L. William Pearce
Vice President724-682-5234
Fax: 724-643-8069February 17, 2005
L-05-015U. S. Nuclear Regulatory Commission
Attention: Document Control Desk
Washington, DC 20555-0001**Subject: Beaver Valley Power Station, Unit Nos. 1 and 2
BV-1 Docket No. 50-334, License No. DPR-66
BV-2 Docket No. 50-412, License No. NPF-73
License Amendment Request Nos. 325 and 195**

Beaver Valley Power Station, Unit Nos. 1 and 2 License Amendment Request Nos. 325 and 195

FENOC Evaluation of the Proposed Change

Subject: Application for Amendment of Technical Specifications 3/4.7.7 (BVPS-1 and 2) and tables associated with 3.3.3.1 (BVPS-1) regarding Control Room Habitability Systems.

Simplified Figure
BVPS Control Room Ventilation Systems

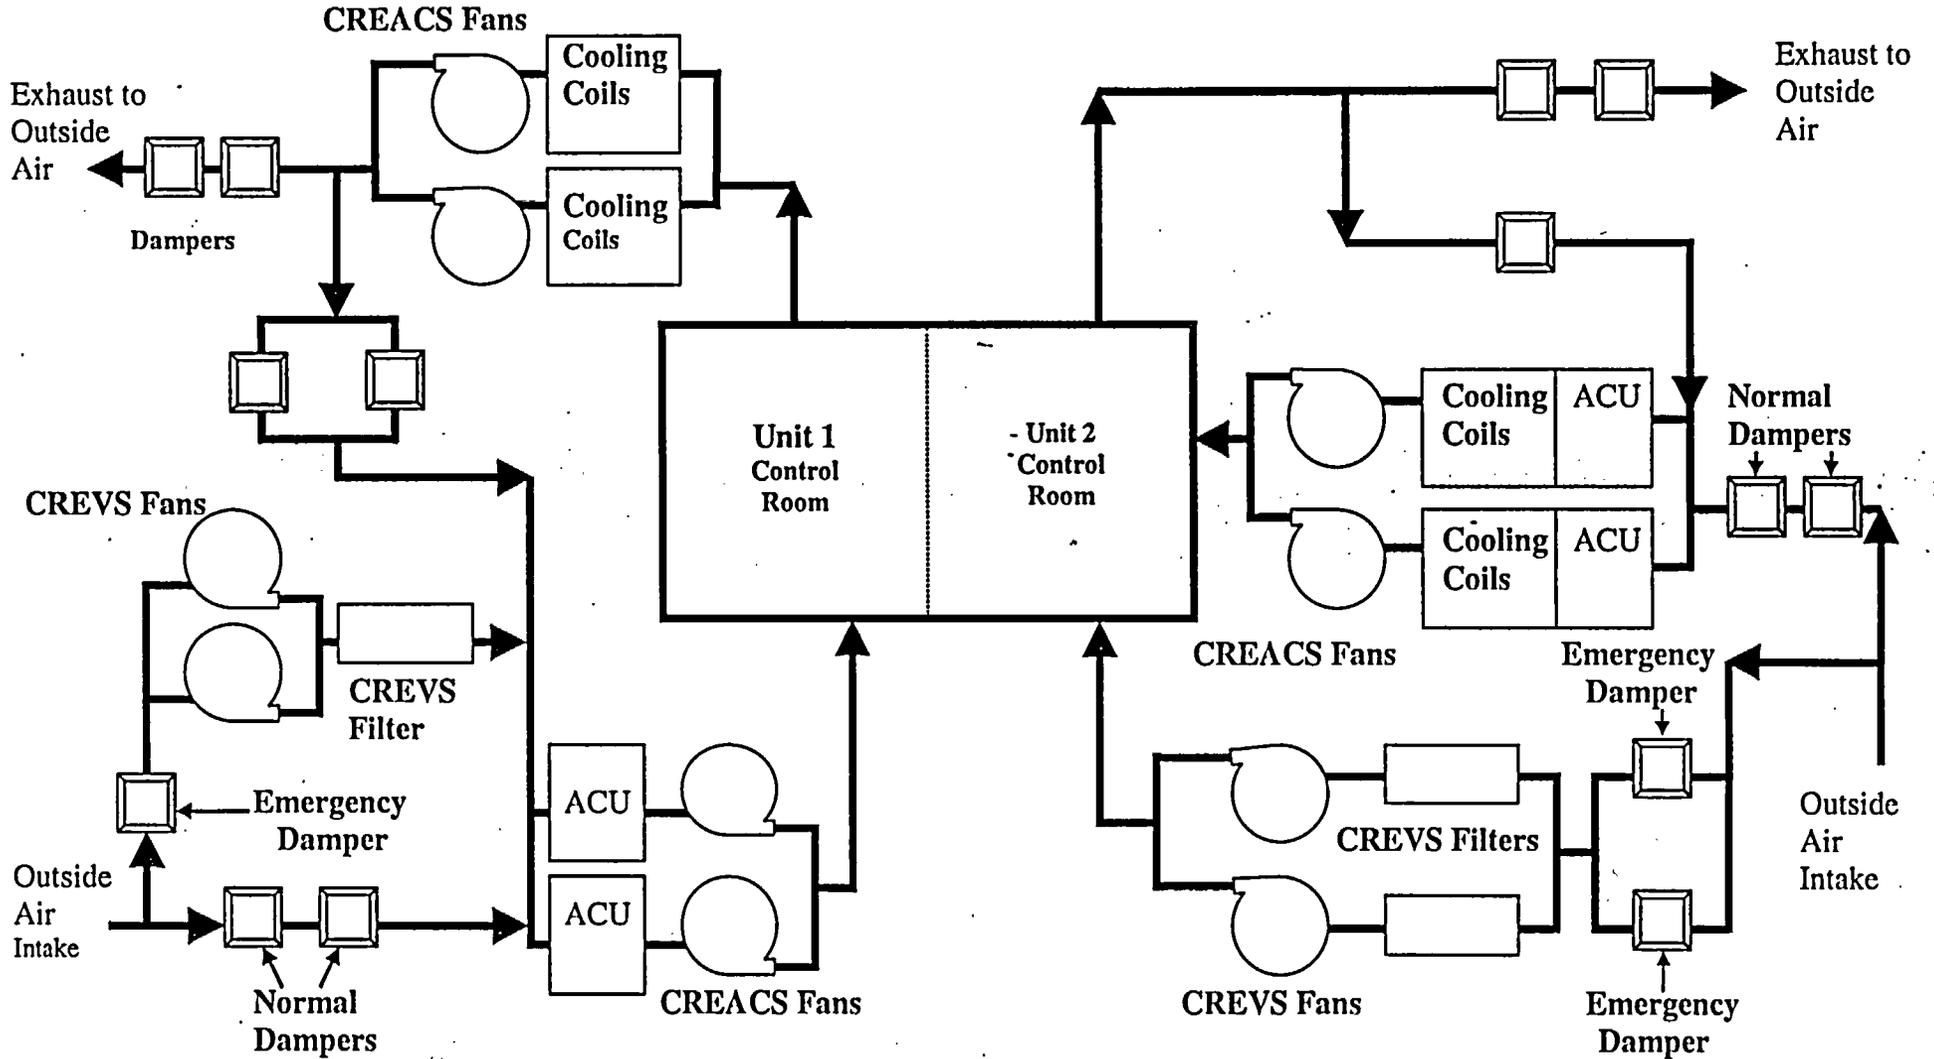
The proposed amendments would revise the Control Room Habitability Systems Technical Specification for each BVPS Unit. Each BVPS Unit's control room habitability systems include its own Control Room Emergency Ventilation System (CREVS) and Control Room Emergency Air Cooling System (CREACS). These control room habitability systems meet the regulatory requirements of General Design Criteria (GDC) 1, 2, 3, 4, 5 and 19 as described in each Unit's Updated Final Safety Analysis Report (UFSAR) (References 4 and 5). The Unit's control rooms are both a positive pressure design and share a common pressure envelope. A simplified figure showing the Unit 1 and Unit 2 CREVS and CREACS arrangement is provided immediately following Section 7 of this LAR.

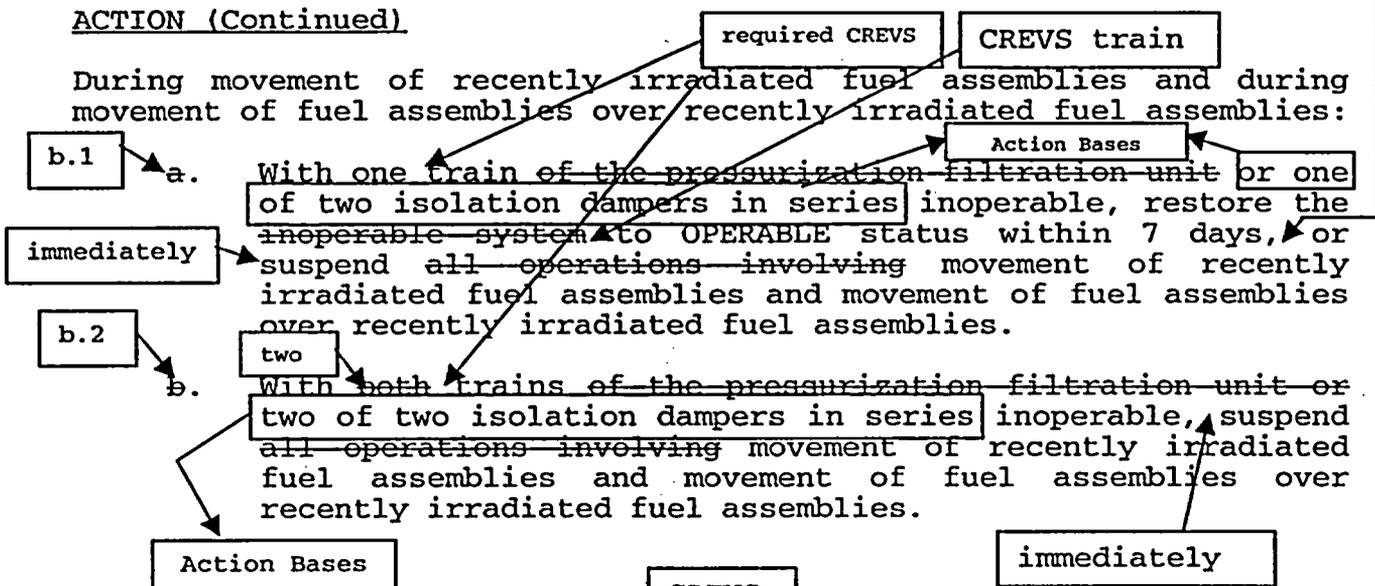
- General Note -

The control room boundary may be opened intermittently under administrative control.
